MONTGOMERY COUNTY HISTORIC PRESERVATION COMMISSION
STAFF REPORT

Address:	11 Montgomery Ave., Takoma Park	Meeting Date:	12/20/2023
Resource:	Contributing Resource Takoma Park Historic District	Report Date:	12/13/2023
Applicant:	Craig & Brandi Sharman	Public Notice:	12/6/2023
Review:	HAWP	Tax Credit:	no
Case Number:	1051631	Staff:	Dan Bruechert
Proposal:	Partial Demolition and Rear Addition Alteration

PROPOSAL

PROPOSED REAR ELEVATION

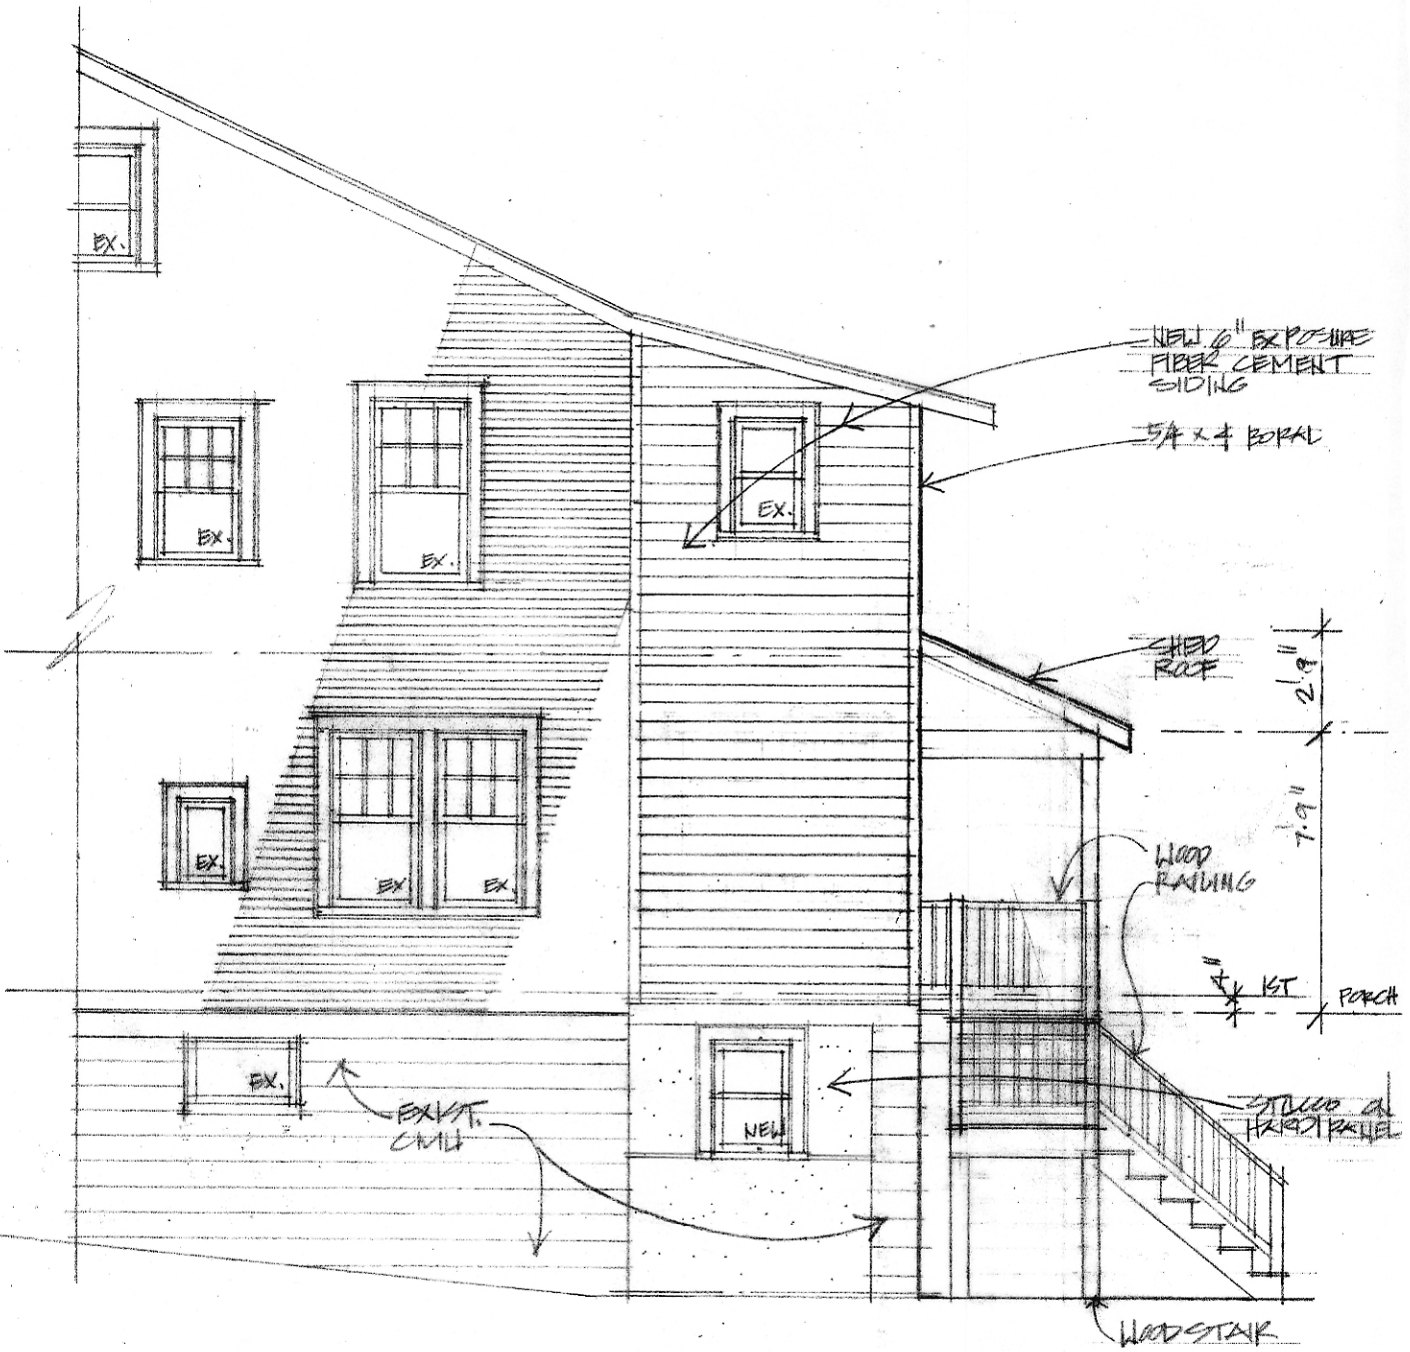
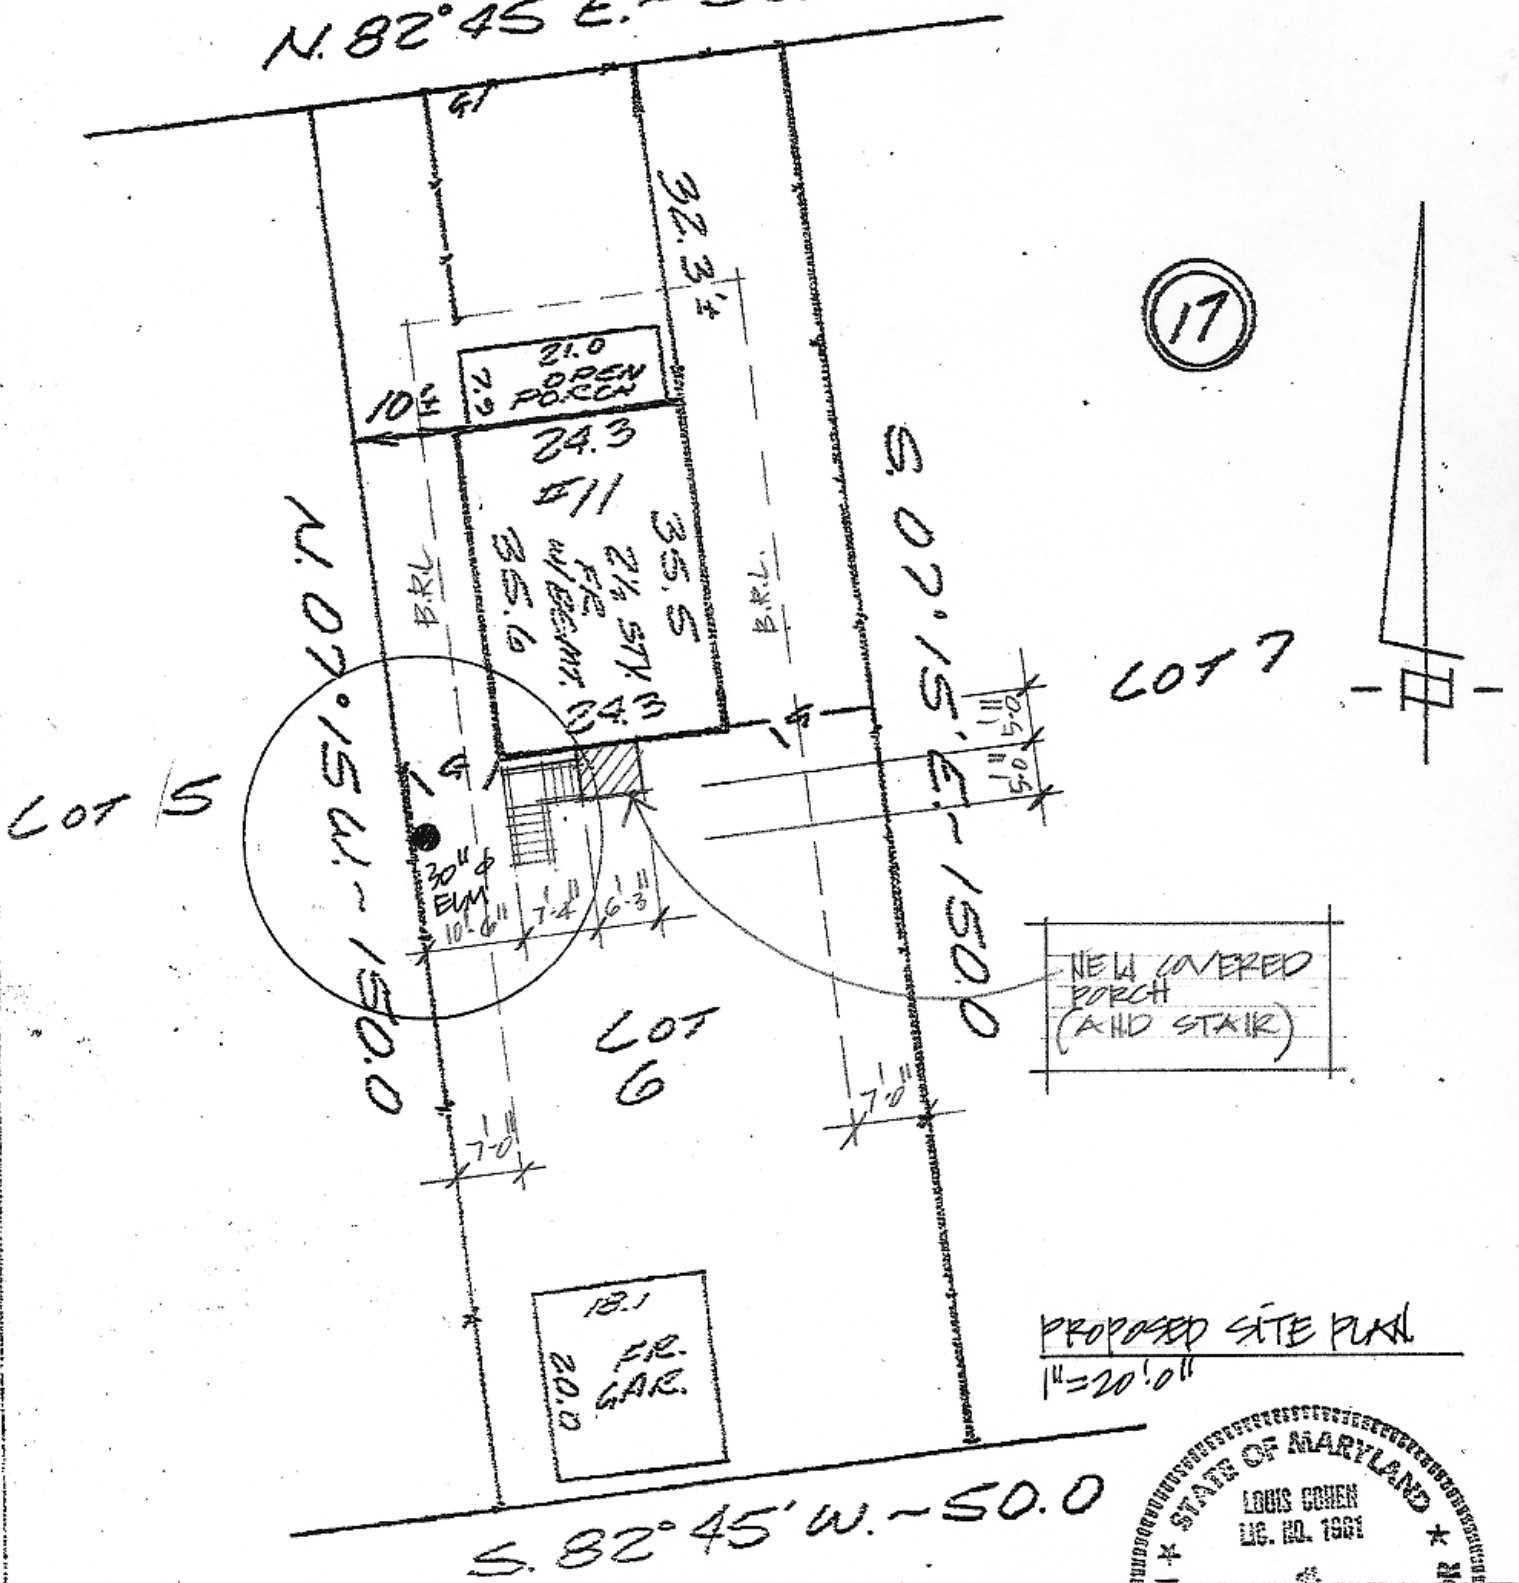
While the proposal is compatible with the District, the application is missing several details regarding materials and there is information missing from the drawings. Staff has written a condition requiring that AZEK be noted in elevation in all locations where it is proposed, that the Hardi panel have a smooth

1. AZEK shall be noted in elevation in all locations where it is proposed.
2. The Hardi panel siding shall have a smooth finish and this shall be noted on all drawings and specification sheets.
3. The window and door schedules shall be annotated to note the chosen profiles and spacer bars.
4. The “Typical Exterior Trim- Half Size” detail shall be updated to show the precise dimensions of the AZEK backband.
5. The handrail details shall be updated to note that the railing caps will be wood.
6. All elevation and plan drawings shall be updated to note the porch and stair floorboards shall be wood or Aeratis. If Aeratis is chosen, specification sheets shall be submitted as part of the revised set of drawings.

TYPICAL EXTERIOR TRIM
HALF SIZE

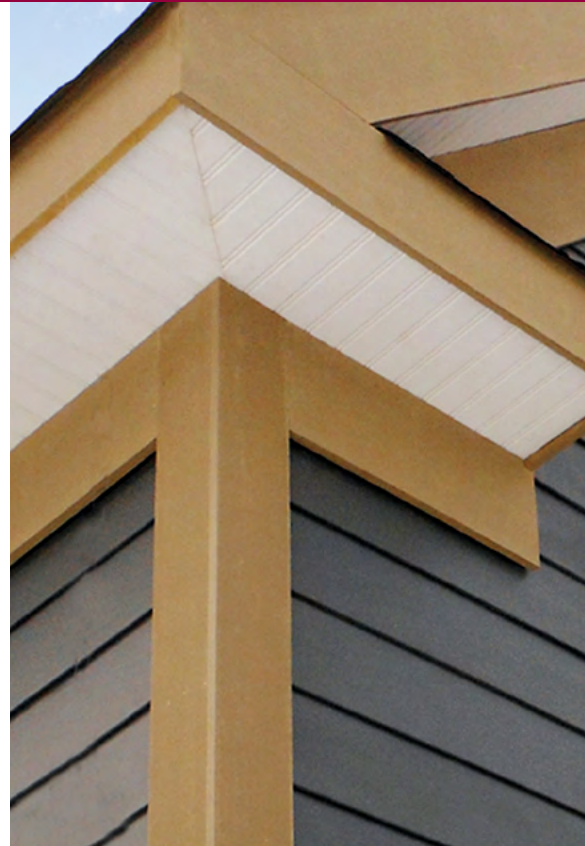
finish, that the window and door schedules be annotated to note the chosen profiles and spacer bars, that the “Typical Exterior Trim- Half Size” detail be updated to show the precise dimensions of the AZEK backband, and that the handrail details be updated to note that the railing caps will be wood. Additionally, the plans do not call out a material for the flooring for the new stairs and porch flooring. Per previous HPC approvals, wood or Aeratis are acceptable materials. A condition has been proposed requiring revision of the drawings to show this material detail.
